Vmark vs Imark at Typical Conditions

IEEE802.3at

March 2009

Simulation Results with Typical PSE numbers

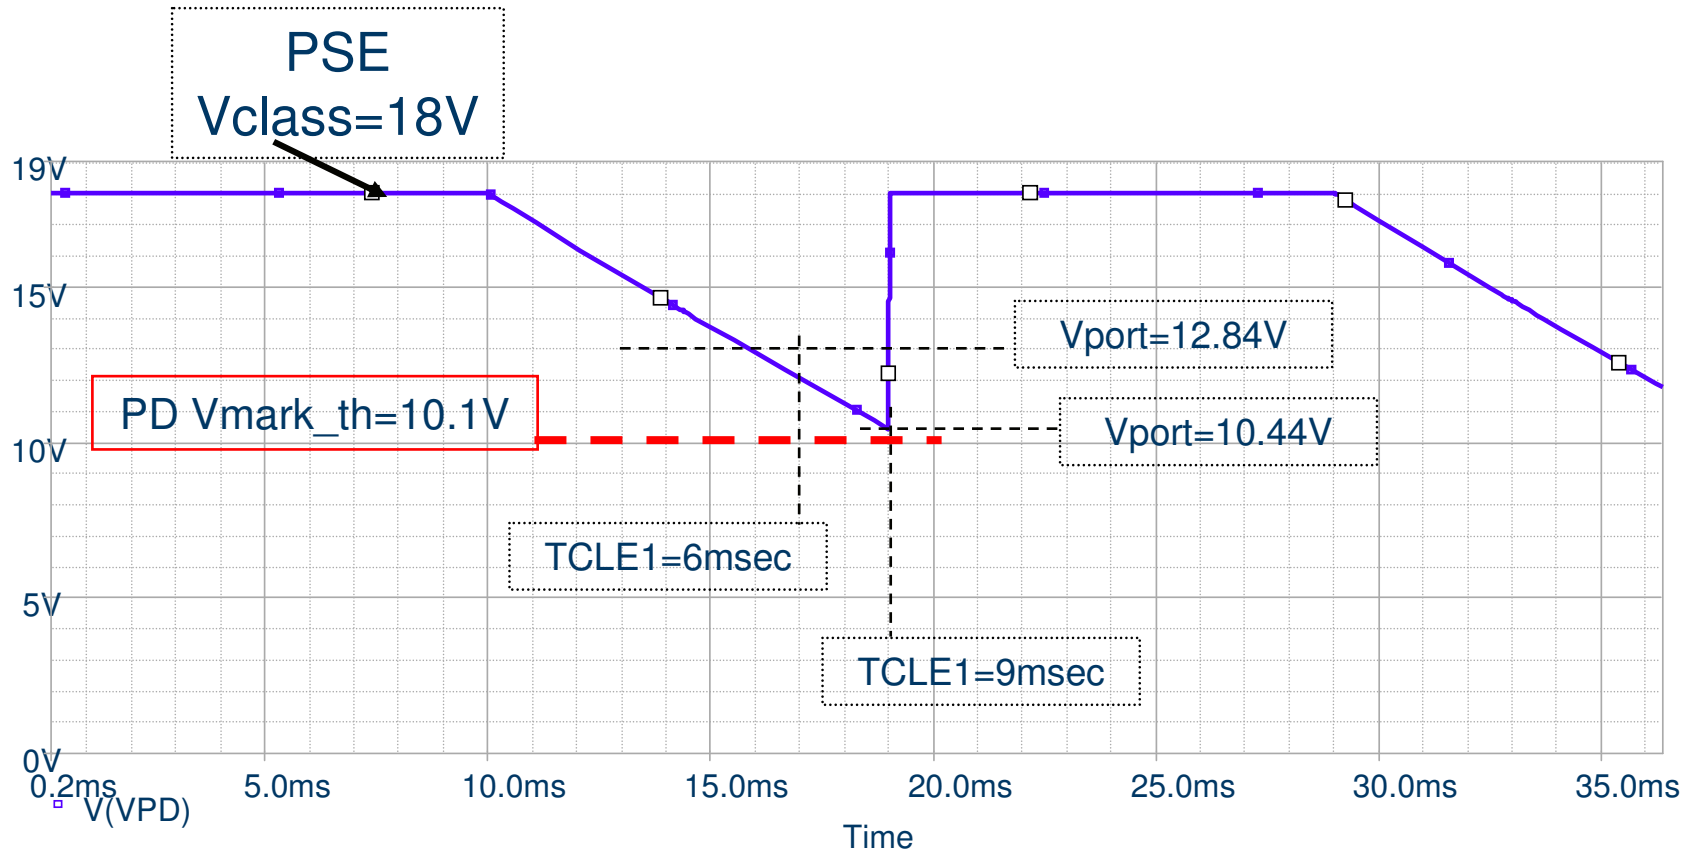
We still have problem

- The voltage at the port during Mark event will be: $V_{class} - 0.25mA * 9msec / 0.31\mu F = 10.5V > V_{mark_th}$
- Conclusions:
- We dont want to change legacy parameters but we can do simple change that will fix the issue: To require PD to consume I_{class} as long as $V_{port} > V_{mark_th}$.
- Under the current specification If PD V_{mark_th} is close to 10.1V and its $I_{mark} = 0.25mA$ for the entire V_{class} V_{mark} ranges and PSE port voltage is not discharged below V_{mark_th} then PD can not detect the 2nd Classification attempt.

Suggested Remedy

- (To require PD to consume Iclass as long as $V_{port} > V_{mark_th}$.)
- Add the following item after item 4 in Table 33-17:
Item: 4.1, Parameter: Mark_event threshold current,
Symbol: Imark_th, Units: mA, Min: Iclass, Max: Iclass_max,
Additional Information: For $V_{class} \geq V_{port_PD} \geq V_{mark_th}$
